**Subject:** MHI's Responses to US-APWR DCD RAI No.67-715

**References:** 1) "Request for Additional Information No. 67-715 Revision 0, SRP Section: 09.04.04 - Turbine Area Ventilation System, Application Section: Tier 2 FSAR Section 9.4.4," dated September 8, 2008.

Responses to Request for Additional Information  
No. 67-715 Revision 0

Figure 9.4.4-1 Turbine Building Area Ventilation System Flow Diagram (Sheet 2 of 2)

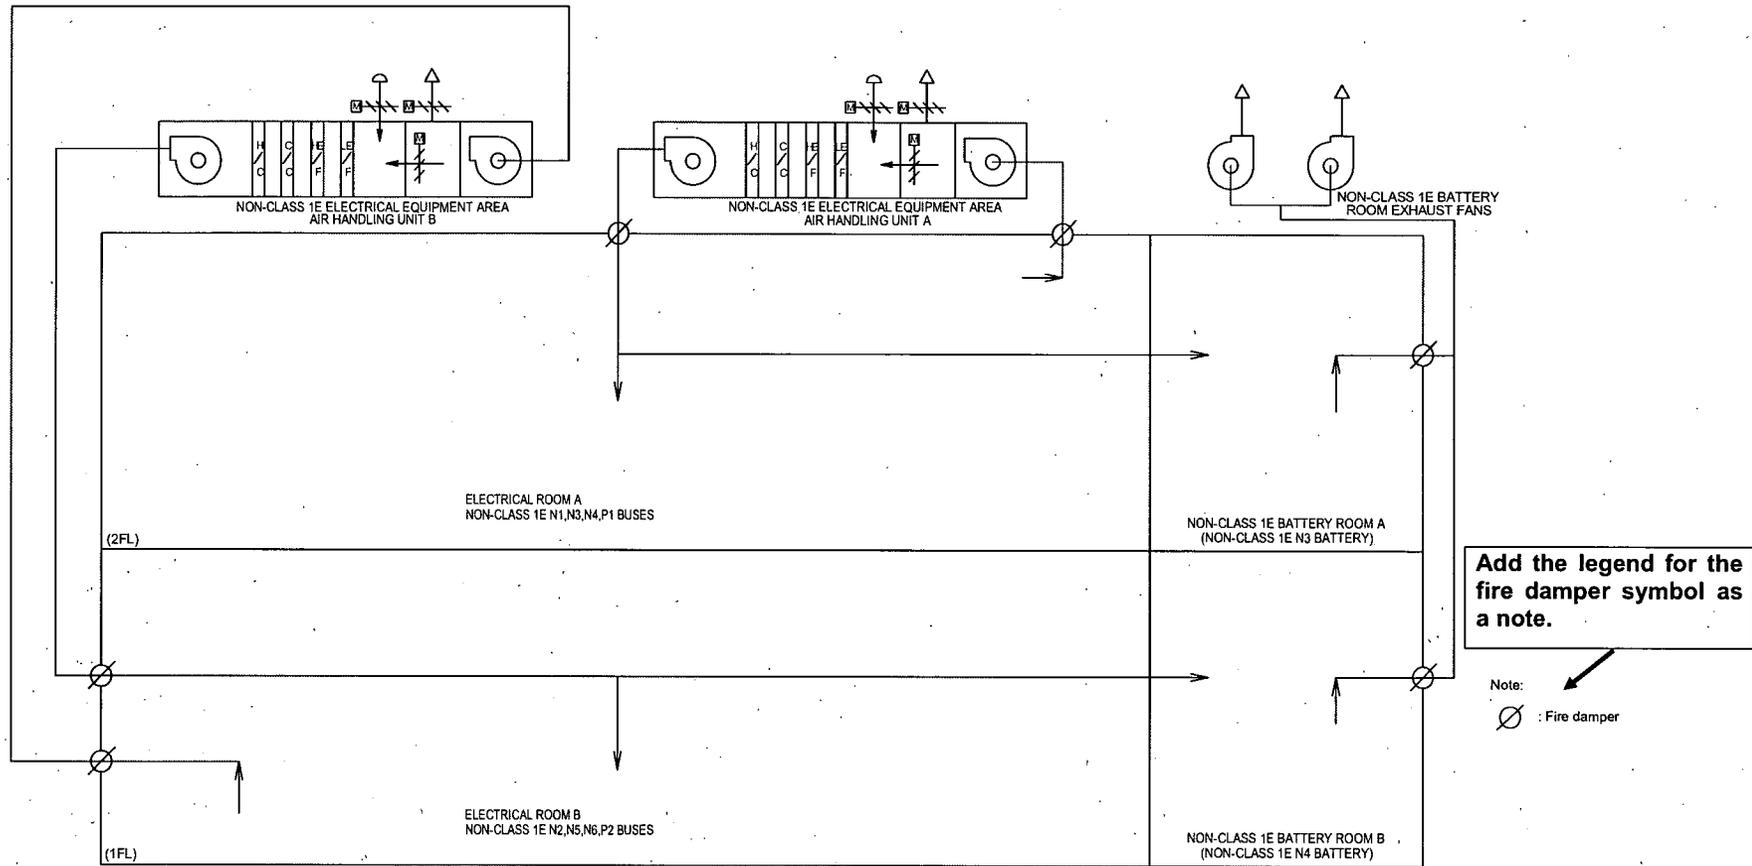
The Fire Protection system Figure 9.4.4-1 (Sheet 2 of 2) "Turbine Building Area Ventilation System Flow Diagram" displays six symbols (i.e. circle with a diagonal line) in the flow process lines. These symbols are not identified in: (1) Figure 1.7-4 Legends for Piping and Instrumentation Diagrams of HVAC System; (2) any legend contained in DCD Chapter 9; (3) Tier 1. Review of DCD Section "9.5 Fire Protection" and Appendix 9A (reference Table 9A-3 for Fire Zones FA6-101-03 & FA6-101-14 and Figures 9A-21 & 9A-22) would lead to the conclusion that the six symbols are most likely fire dampers. The staff asks that the applicant remove the ambiguity of the six symbols from the DCD. If these symbols represent fire dampers, they should be described as a Fire Protection System interface in DCD Section 9.4.4 with respect to the Turbine Building Ventilation System. The staff request that clarification of the six symbols be added to DCD Section 9.4.4.

MHI concurs with NRC with the ambiguity of the symbols. The six symbols in Figure 9.4.4-1 (Sheet 2 of 2) represent "fire dampers". Figure 9.4.4-1 (Sheet 2 of 2) will be revised to add the legend for the fire damper symbol as a note.

Revise Figure 9.4.4-1(Sheet 2 of 2) to add Legend for Fire Dampers as attachment.
